SUBJECT: Elemet Group Site Plan Review

Memorandum

Re: Elemet Group Building Site Plan Review

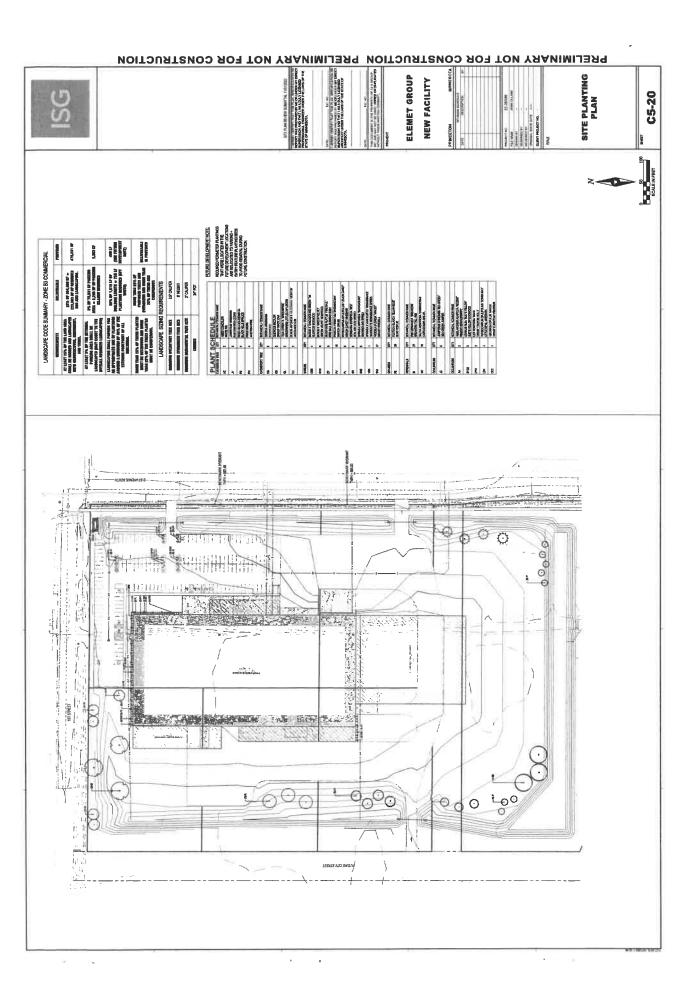
- 13. The grading plan does not show how the existing ditch is being directed around the building. Label existing elevations in the ditch along 1st Street. I

- a. Elevations from the plan set do not match the HWL in the stormwater narrative. Plan show HWL for both basins at 981.01, while modeling shows 980.79. Verify HWL and update modeling and plans to reflect the same information
 - i. 3' of separation will be required from the 100 HWL to any FFE in this addition or any other proposed projects onsite.
- b. Provide an EOF route for all low areas within the proposed site. EOF's shall have stabilized rock outlets to prevent erosion.
 - i. EOF's must be a minimum of 1' lower than the FFE
